Addendum 2

Project: **WJUSD ADULT ED CTE CLASSROOM RENOVATIONS**
Project Number: **21-W04-01**

Owner: **Woodland Joint USD**

A/E: **Synthesis Partners, LLC**
PO Box 1900
Yuba City, CA 95992

PARTIAL ROOF FRAMNG PLANS

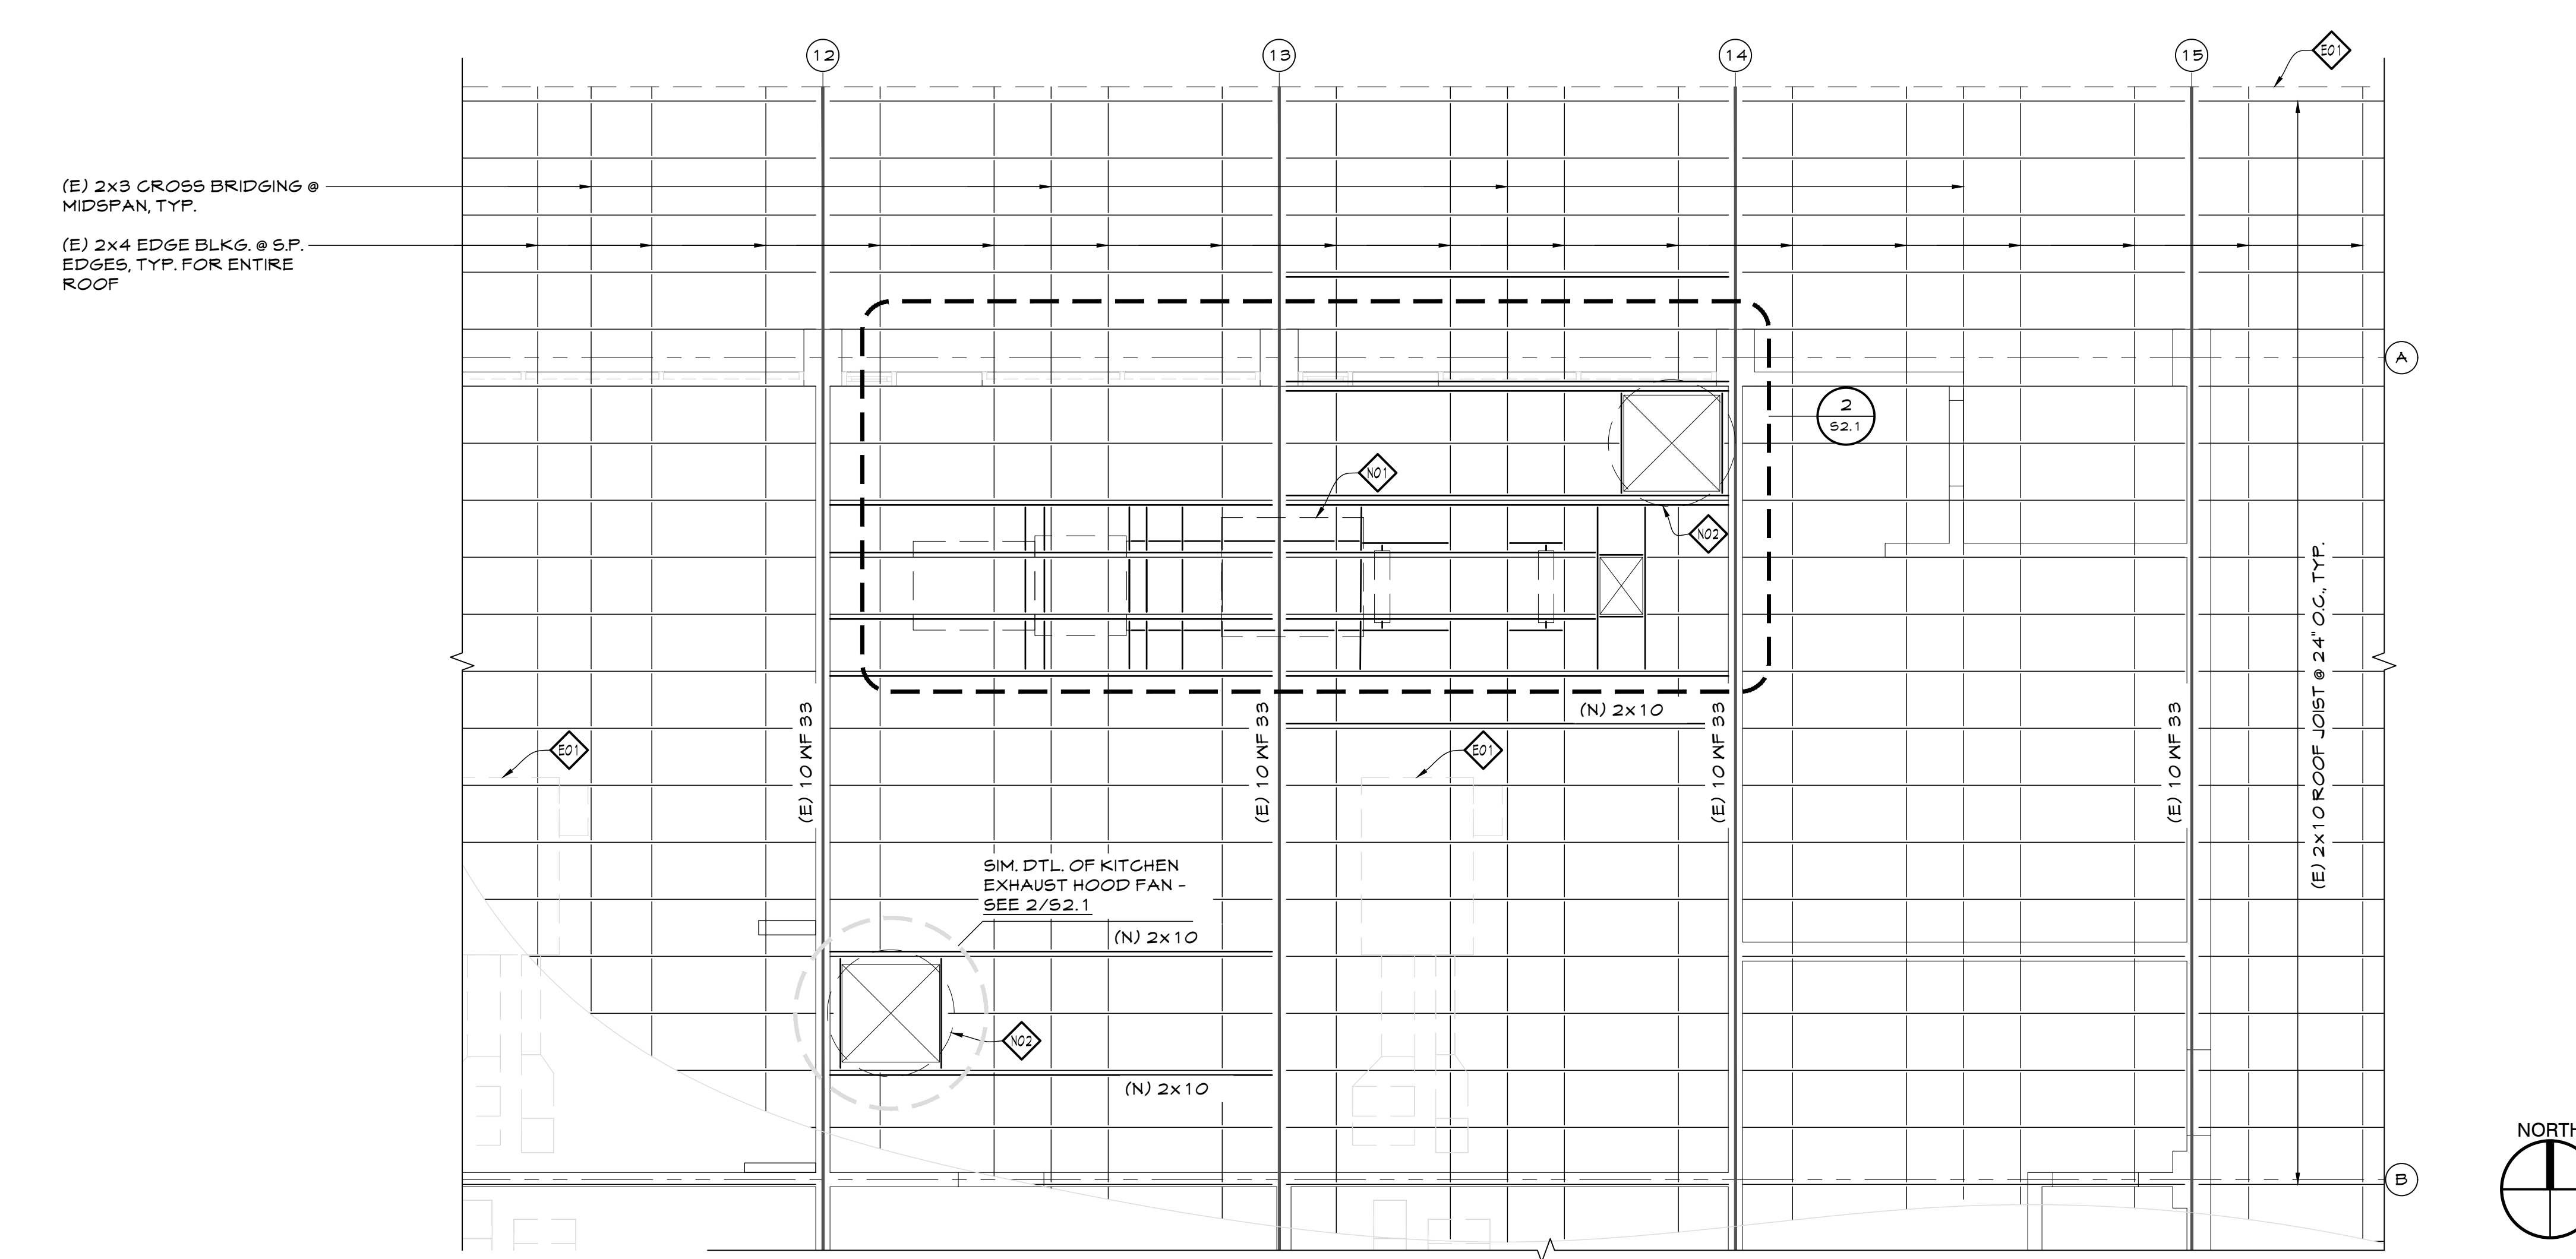
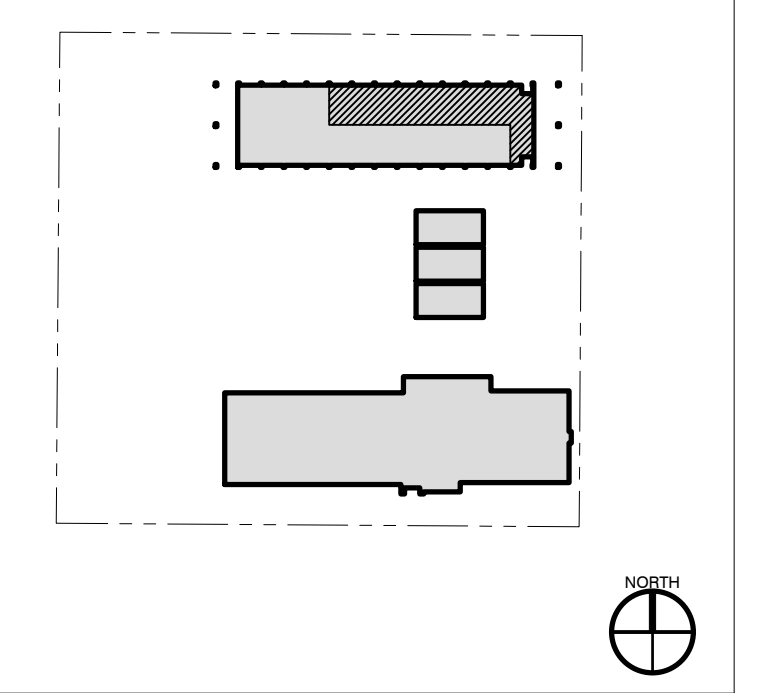
AD2C.01 Added structural drawings (S0.1, S2.1, S2.2) for clarification of HVAC support framing.
AD2C.02 Revised Mechanical drawings to address DSA comments (M0.2, M0.5, M2.1, M5.1,
M5.2). Revisions are clouded.
AD2C.03 Revised Plumbing drawing (P0.1) for corrected water heater model.
AD2C.04 Revised Electrical drawing (E1.1) to provide a scalable site plan.

1 SITE PLAN - ELECTRICAL
E1.1 1" = 40'-0"

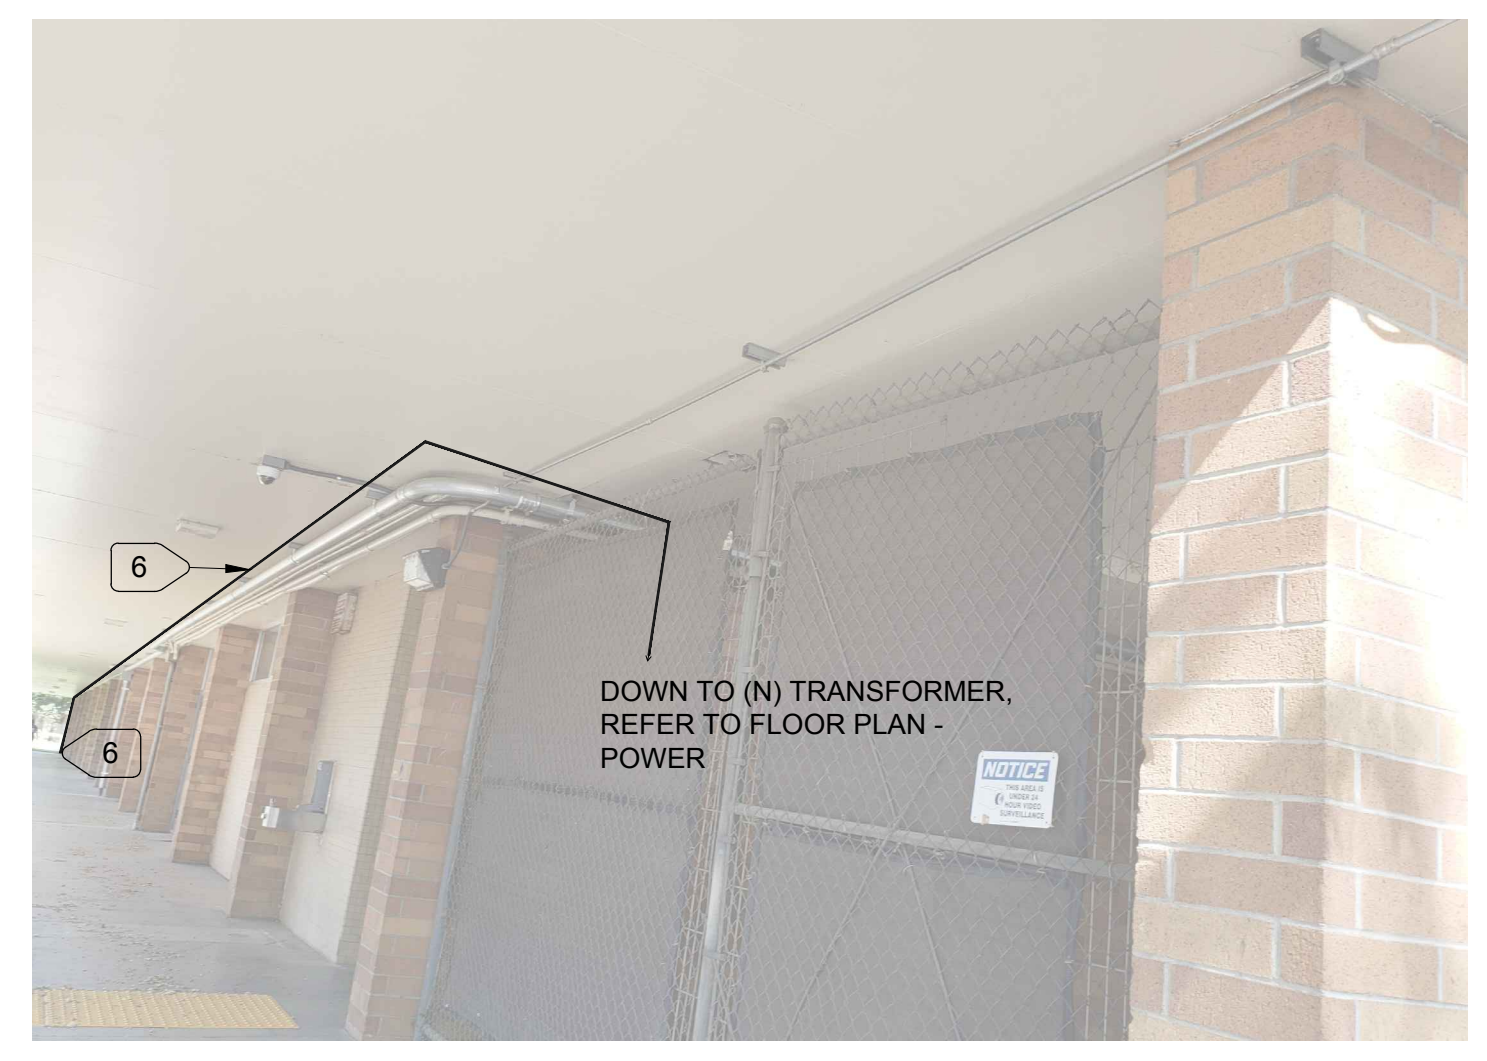
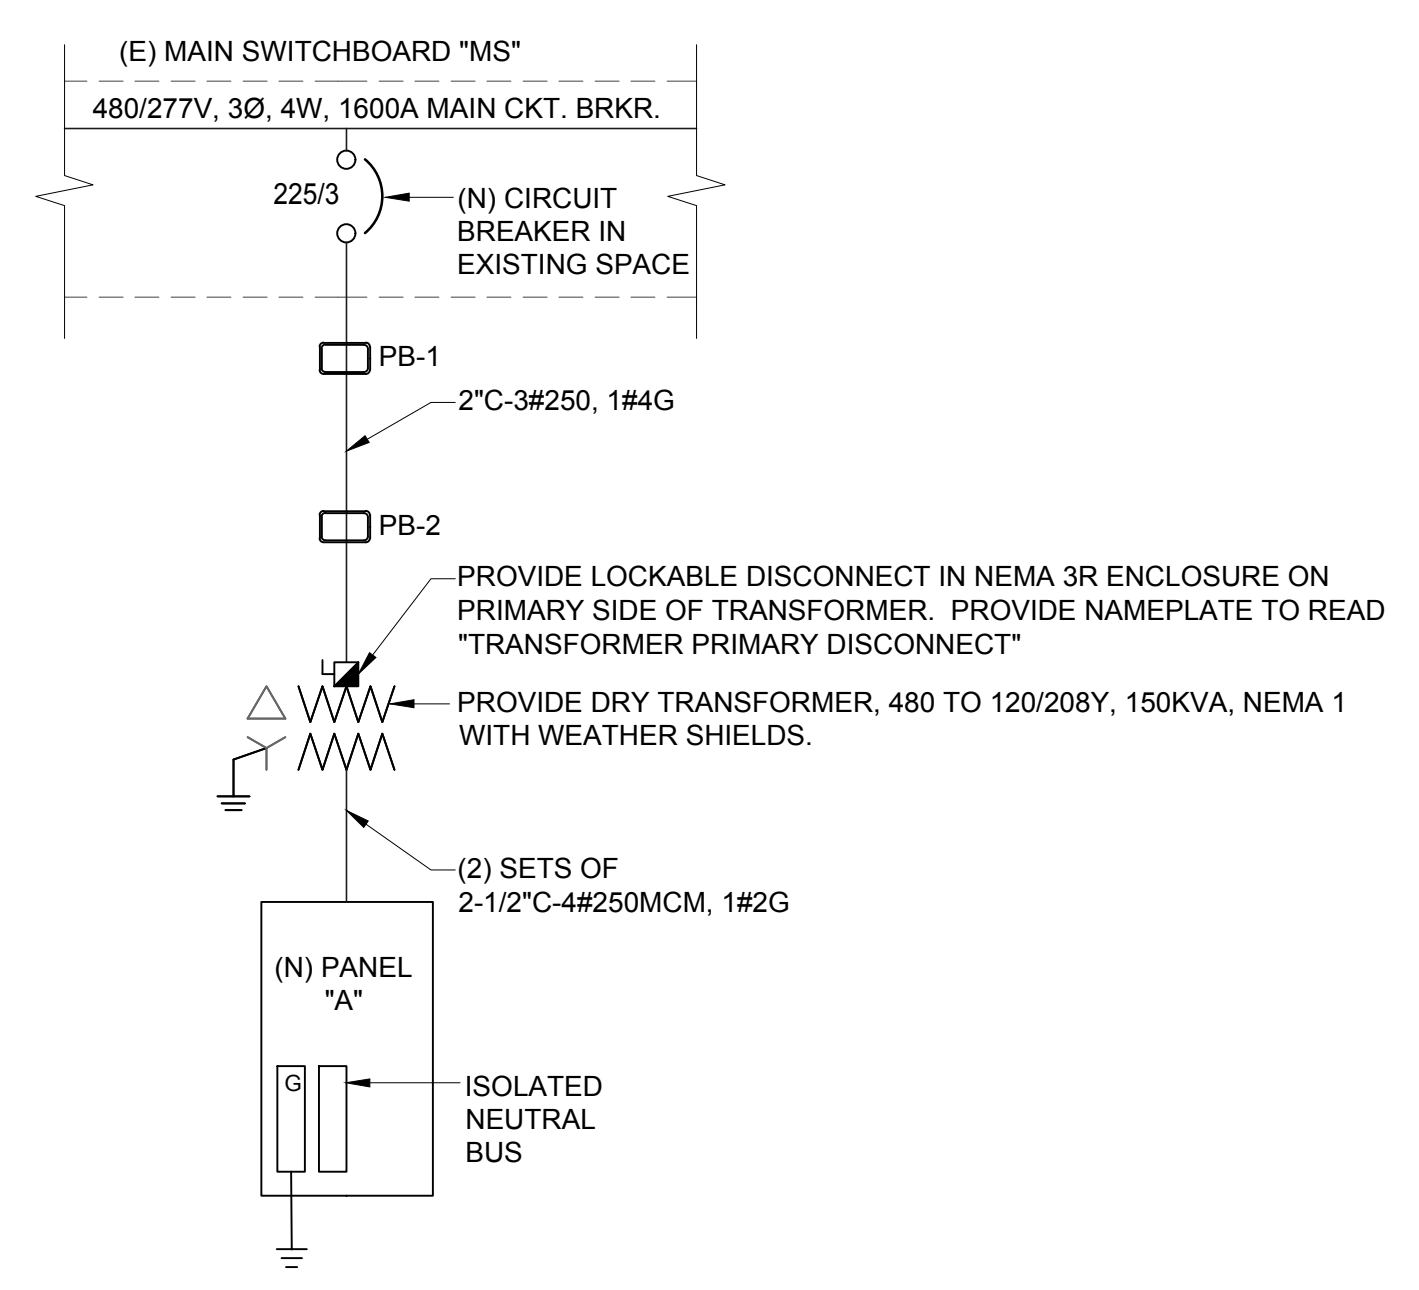
- AD2D.18 Please provide a scalable Electrical Site Plan. Currently provide on E1.1 appears to be a picture and is NTS.
- a. See revised E1.1 in this addendum for scaled site plan.
